Service Bulletin

Bulletin No.: 16-NA-179

Subject: Wear Condition or Fraying of Headliner at Sunroof Module Rear Opening

Brand:	Model:	Model Year:		VIN:		Engine:	Transmission:
		from	to	from	to		
Chevrolet	Impala (VIN 1)	2014	2017			All	All

4532664

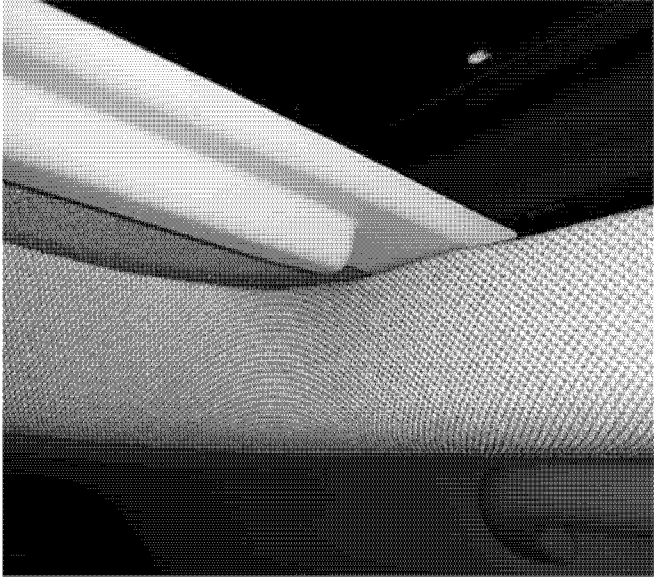
<p data-bbox="1419 749 1484 768">4532667</p> <p data-bbox="539 778 1461 853">Some customers may comment on seeing a worn area or fraying of the headliner at the sunroof module rear opening. Examples of the wear condition are shown in the graphics above.</p>
<p data-bbox="131 1221 204 1247">Cause</p>	<p data-bbox="539 868 1461 921">The cause of the condition may be due to a contact condition between the headliner and the sunroof module when cycling.</p>  <p data-bbox="1419 1523 1484 1542">4528614</p> <p data-bbox="539 1551 1435 1604">Lack of clearance between the sunroof sunshade and the rear headliner opening may result in a touch condition that leads to edge fray of the headliner over repeated use.</p>

4528616

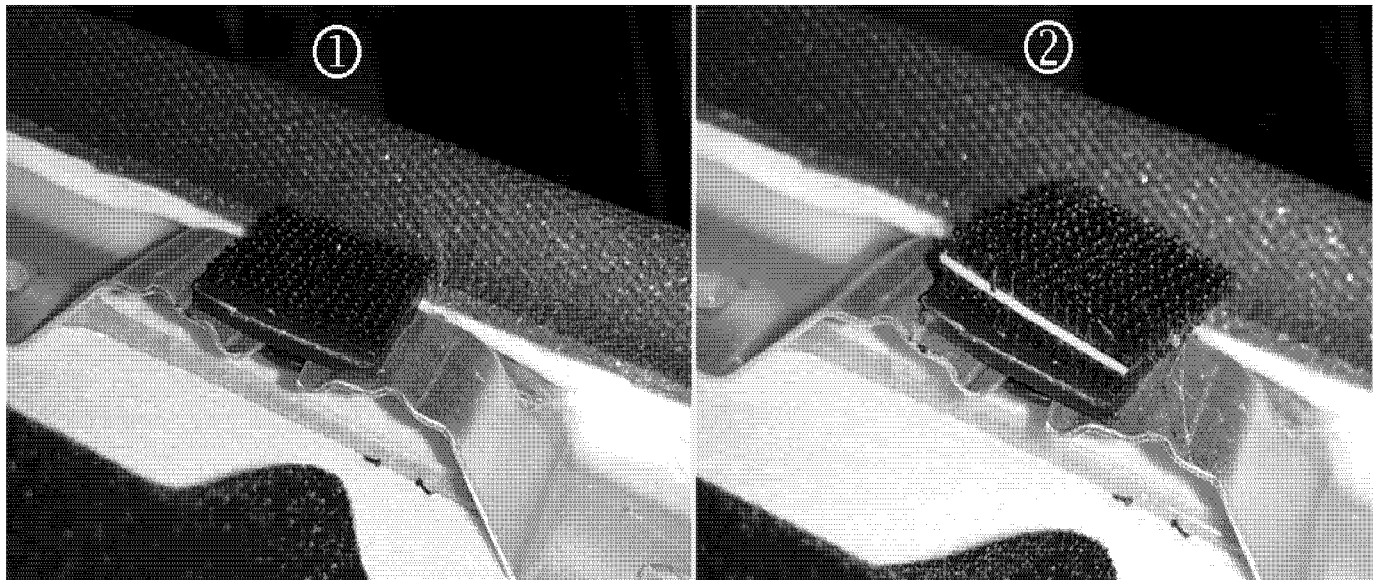
For vehicles displaying the condition it will be necessary to replace the headliner, but prior to installation, also add "double" layer spacers (1) to the single lock retainer (2) at some locations on the new headliner.

4528621

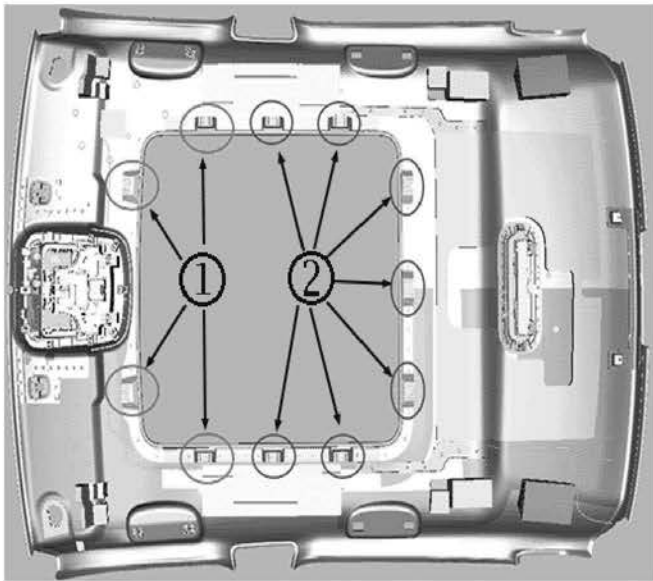
The original headliner should have contained a combination of single (1) and double (2) dual lock retainers.

Commonly, there should be four double dual lock retainers (1) at the front headliner opening, and seven single dual lock retainers (2) at the sides and rear. Transfer the existing double dual lock retainers and add the service part spacer listed below to all single dual locks, and transfer those. Ensure double dual locks secure the headliner around the entire sunroof opening.
